**TOWN OF ERIE
PLANNING COMMISSION MEETING
April 3, 2019**

SUBJECT: Spring Hill Sketch Plan - A Sketch Plan represents a generalized land use plan and layout for the area proposed to be included within a subdivision. A Sketch Plan application is required to allow for an early, informal evaluation of a proposed subdivision before detailed planning and engineering work has occurred.

PURPOSE: Planning Commission review and comment on a Sketch Plan application for of 632 lots and 33 tracts as well as right of way, parks, and open space.

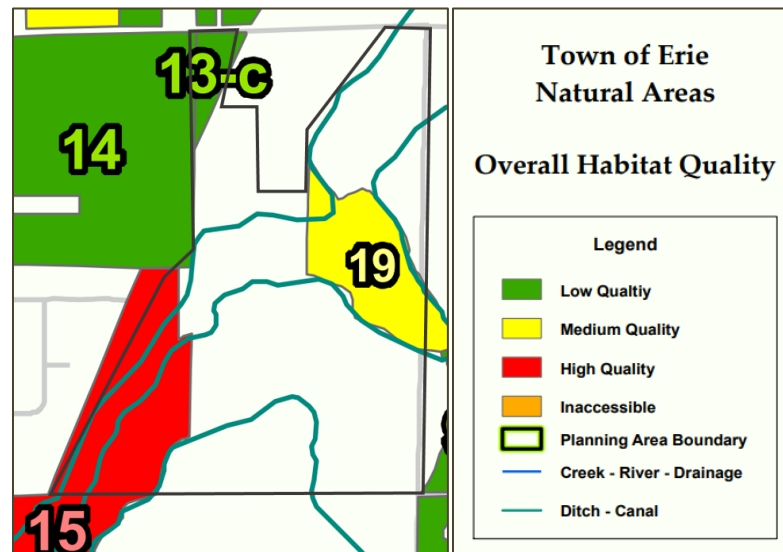
The proposed plan does not align with the Comprehensive Plan Land Use designation for this property. The approximately 70 acre area south and west of the Cottonwood Extension ditch is shown as Agriculture on the Comprehensive Plan. According to the Comprehensive Plan farming, ranching, and other agriculturally related uses and very low density rural residential uses are appropriate in this area. Also, lands designated Agriculture “serve a vital role in defining the history and character of Erie and should be maintained where viable, to serve as gateways and buffers, preserve vistas, and retain the desired character of the Town.” Within this area the sketch plan shows the western edge, the areas adjacent to the western two ditches (Lower Boulder Ditch and the Boulder/Weld Ditch), as open space and develops the remainder at a density consistent with an LDR land use designation. The LR Zone Designation (which defines allowed uses and development standards for those uses) does not negate the need for the subdivision plan to be consistent with the Comprehensive Plan. A Comprehensive Plan amendment allowing the change in Land Use designation from this area would be required to be approved for this subdivision plan to conform to the Comprehensive Plan.

The Land Use Plan Map identifies, with a green flag, a future Saint Vrain Valley School District school site on the property. The sketch plan anticipates and provides a 10 acre elementary school site.

Overall Sketch Plan

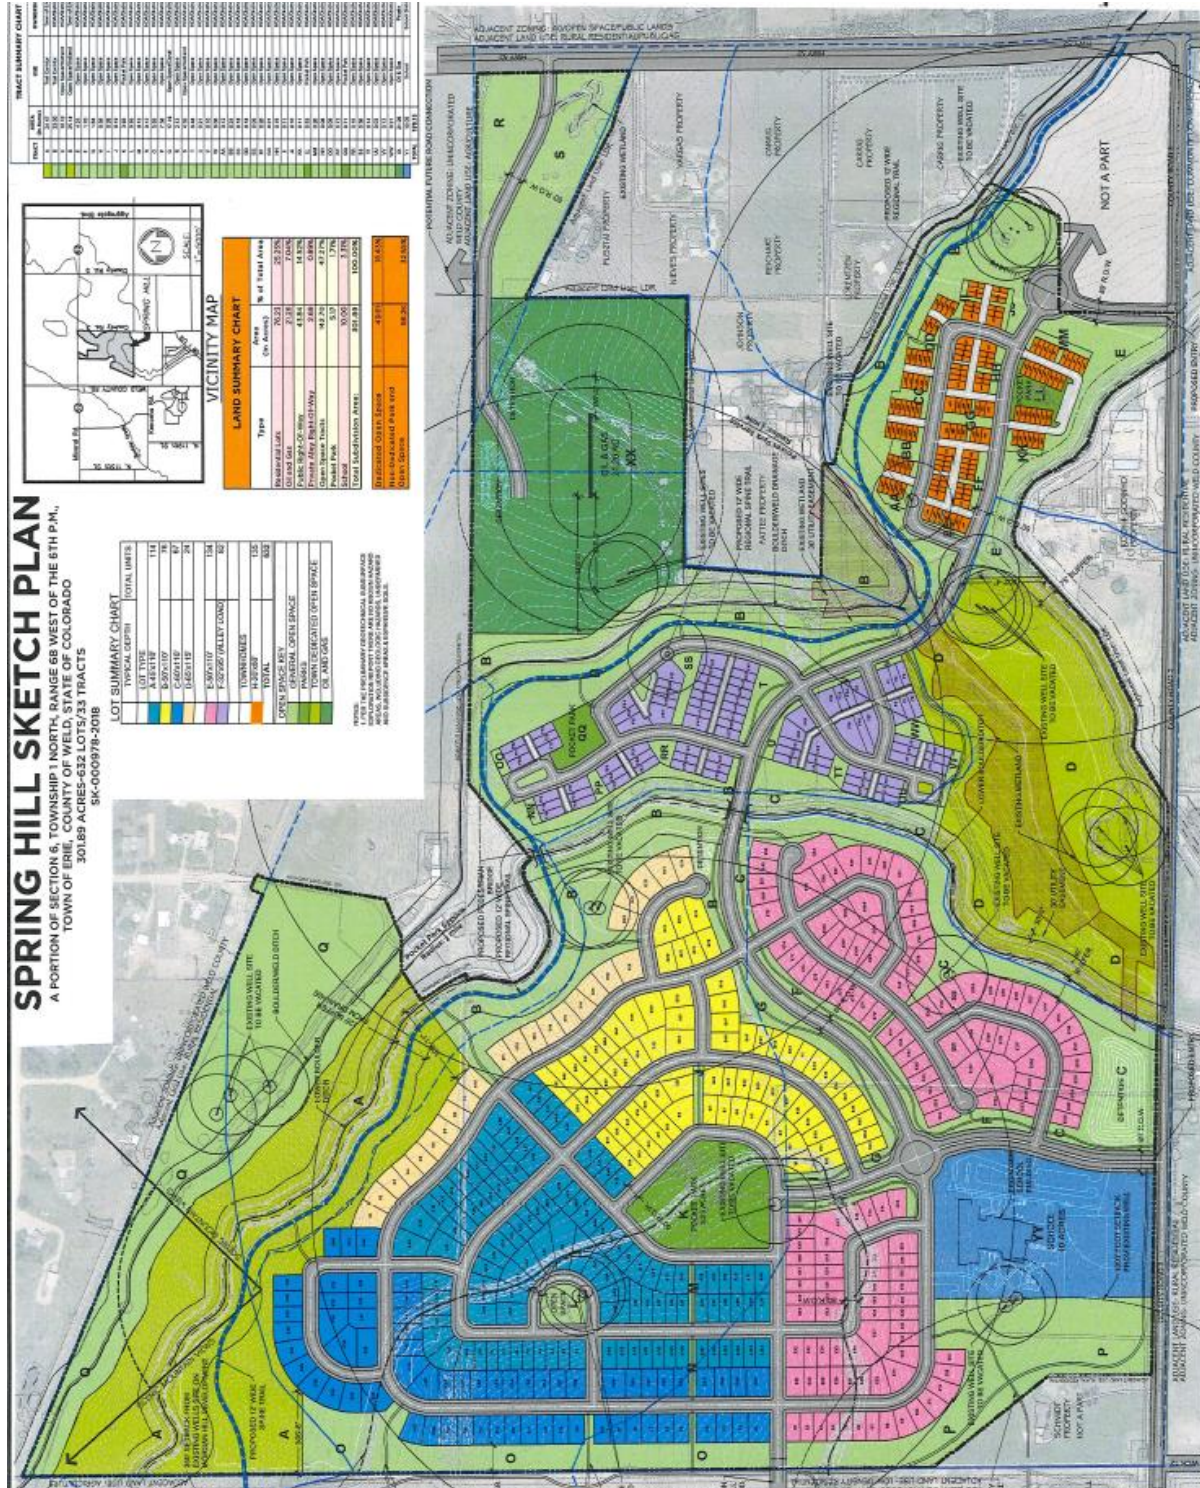
The application proposes a total of 632 lots, tracts, parks, open space, right of way and an oil and gas operation area.

The UDC requires 4 housing types or 3 housing types and one variation on a development of this size however; the annexation agreement for this property modified the requirement by stating “the property shall be required to provide not more than one (1) housing type and two (2) housing type variations”. By providing single family detached housing with a range of lot sizes, front and alley loaded variations, as well as townhouses the applicant will exceed the annexation agreement.

With 632 dwelling units included in the Sketch Plan the overall parks and open space dedication requirements apply: Neighborhood Park 5.48 acres; Pocket Park 0.91 acres; Community Park 9.13 acres; Open Space 31.05 acres. A Neighborhood Park is not required since the 7 acre minimum was not reached however, the Neighborhood Park Land and Development Construction Cost Fee will apply. The Community Park is not required as the 30 acre minimum is not met.

The applicants proposed Sketch Plan includes construction of the roads within the subdivision which connect County Road 3 to the east and the Morgan Hill property to the south. Improvements to adjacent existing roads will be necessary.

Within the subject property the proposed Sketch Plan anticipates the closure of the existing oil and gas wells and associated facilities. These operations are proposed to be relocated to a 21.26 acre area in the northwest portion of the property where a separate access point into Highway 52 would be developed.

Other oil and gas operations exist to the south of the project within the Morgan Hill development. The Sketch Plan shows a 1,000 foot setback from the wells located south of the school site and a 350 foot setback from the wells on the west side of Morgan Hill.
